## SOLICITATION AMENDMENT

<b>Title - Sujet</b> Remote Weapon System	
<b>Solicitation No. - N° de l'invitation</b> W8486-184951/A	<b>Amendment No. - N° modif.</b> 005
<b>Client Reference No. - N° de référence du client</b> W8486-184951	<b>Date</b> 2018-09-11
<b>GETS Reference No. - N° de référence de SEAG</b> PW-\$SBL-316-26903	
<b>File No. - N° de dossier</b> 316bl.W8486-184951	<b>CCC No./N° CCC - FMS No./N° VME</b>
<b>Solicitation Closes - L'invitation prend fin at - à 02:00 PM on - le 2018-09-21</b>	<b>Time Zone</b> Fuseau horaire Eastern Daylight Saving Time EDT
<b>F.O.B. - F.A.B.</b> Specified Herein - Précisé dans les présentes <b>Plant-Usine:</b> <input type="checkbox"/> <b>Destination:</b> <input type="checkbox"/> <b>Other-Autre:</b> <input checked="" type="checkbox"/>	
<b>Address Enquiries to: - Adresser toutes questions à:</b> Singh, Shailla	<b>Buyer Id - Id de l'acheteur</b> 316bl
<b>Telephone No. - N° de téléphone</b> (819) 921-3988 ( )	<b>FAX No. - N° de FAX</b> ( ) -

## W8486184951 – Letter of Interest Questions and Answers

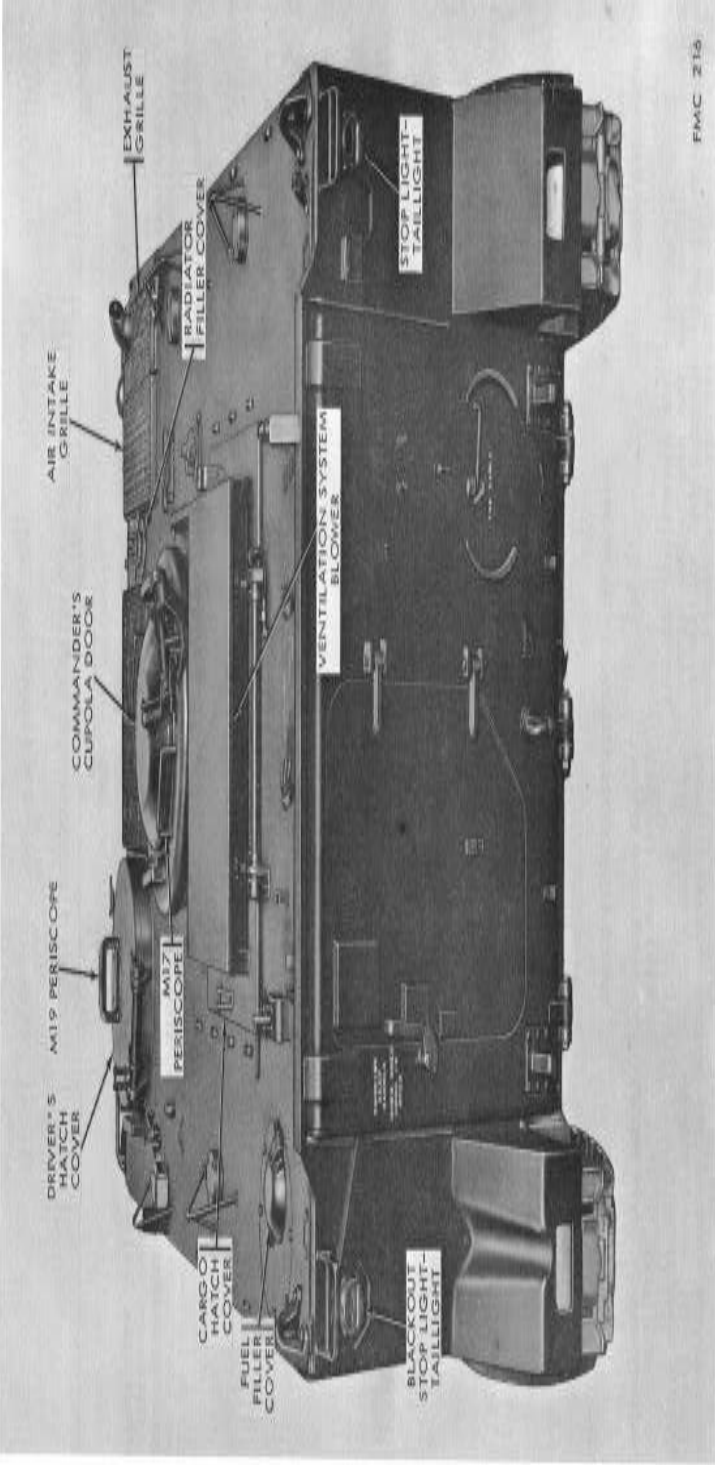
2.	Annex A – Statement of Requirement	Paragraph 2.a.(4)	<p>Paragraph 2.a.(4) states that “ It is essential that the RWS must provide full weapon and firing control to the crew commander while allowing him to command and control the vehicle”. The word “Control” suggest that the Commander is on the Driver Seat driving the vehicle and controlling the Weapon System.</p> <p>Is the Commander driving the vehicle at the same time as being the gunner of the Weapon Station?</p> <p>This seems to be in contradiction with the usual scenario where the vehicle team is made of 2 soldiers (i.e. a Driver and a Gunner/Commander). Please clarify.</p>	<p>Control, in this case, is situational. Being in command of both the vehicle and the crew puts the commander in control of the driver, who sits in the driver’s seat. Crew Commander does not physically need to be able to drive the vehicle from his/her seat.</p>

No.	Reference Number	Article Number	Question	Answer
5.	Annex A – Statement of Requirement		Paragraph 2.a.(5) field of view seems to be associated to the Driver hatch periscope (see figure 1 above). However, paragraph 2.b.(7) seems to be associated to the Commander Cupola (see figure 1 above). Please confirm that the requested 6400 mils (360 degrees) field of view is a combination of the Driver Hatch and Commander Cupola once the Remote Weapon Station is installed on the vehicle roof.	The indicated mils are for the view as per paragraphs 2.a. (5) and 2.b.(7) are both from crew commander cupola. The field of view indicated in 2.a. (5) is essential while the field of view in 2.b.(7) is desired.
